Application Number: 2014-124 **Application Date:** 07/09/2014
CBL: 073 A001001 **Application Type:** Zoning Contract/Conditional Rezoni
Project Name: Mercy Master Plan Update
Address: 175- FORE RIVER PARKWAY
Project Description: Update to the Master Plan to include Phase II Hospital relocation and expansion.

We have received your July 31, 2014 email with preliminary review comments regarding Mercy Hospital's request for an Amended Contract Zone Agreement. For ease of reference, we have repeated your comment (*italics*) followed by our response and Supplemental information.

Policy Questions

The first CZA included a single “Concept Master Plan” (the original was not colored; this is as approved in CZA and was based on MDEP and TMP approvals):

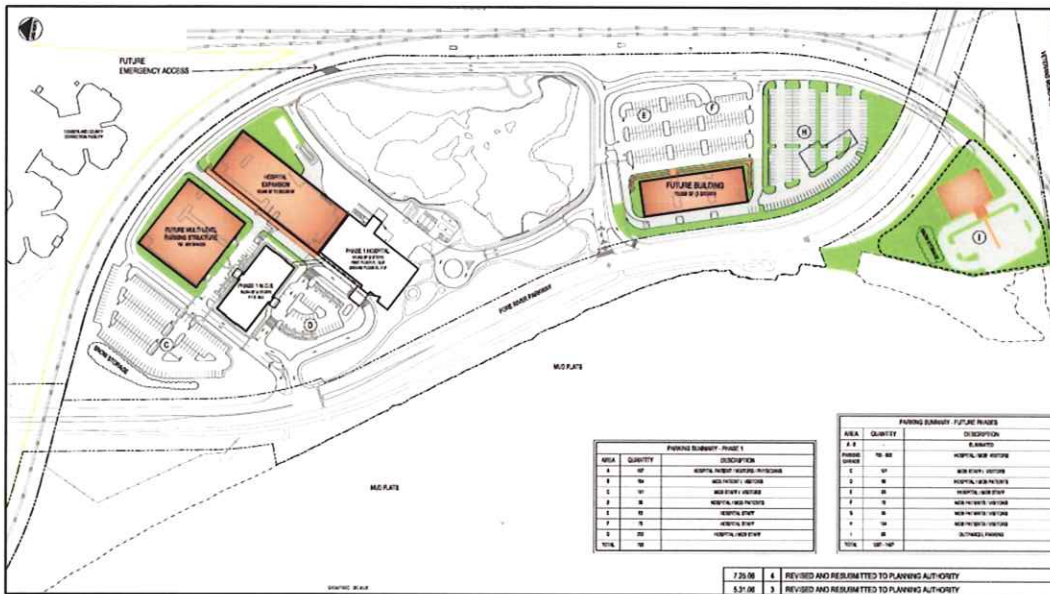
Assuming that the amended CZA should include at least one plan that shows the final intended build out (ie a plan that corresponds with the 2001 and 2006 versions- see **B BACKGROUND** below), there are 2 policy questions regarding the way to handle the phasing and master plan:

- What form should the 2014 revised master plan take; what text/plans etc and what other content to address the likely phasing of the next phase? {the current submission includes (in addition to overall site plan) a grading and drainage plan and utility plan for the "new" build out} ?
- When should the 2014 detailed master plan be prepared- as part of amended CZA, or as part of the next site plan application? Note: the 2006 detailed "Master Plan" was 18 pages of text and 8 plans, and not within the CZA but part of the first site plan, as the CZA required it to be prepared via the following provision:

2006 Approved Master Plan, Plan of Future Phases: (also in Plan P2) Future phases in color, and Phase 1 as complete and not colored

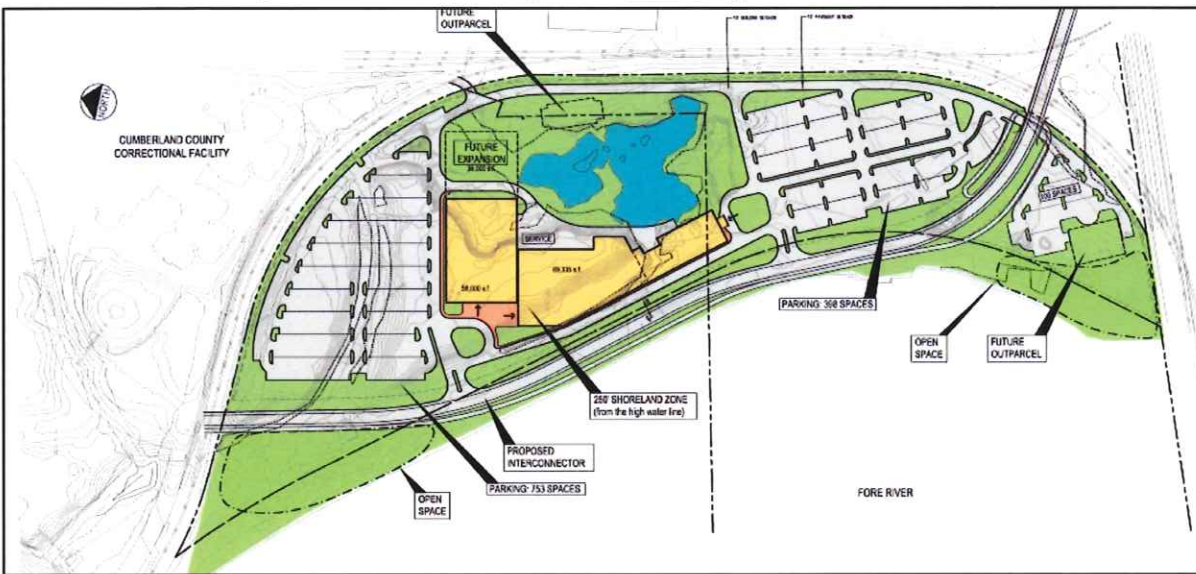
Required reviews: The proposal has been submitted as a request to amend the 2001 CZA as based on earlier staff advice. The detailed submission raises a number of questions regarding whether an amended CZA is required, or whether the applicant could proceed directly to a level III site plan application that includes an updated Master Plan and the next phase of development. This jurisdictional question will be discussed in more detail below and the planning staff are seeking the Board’s guidance
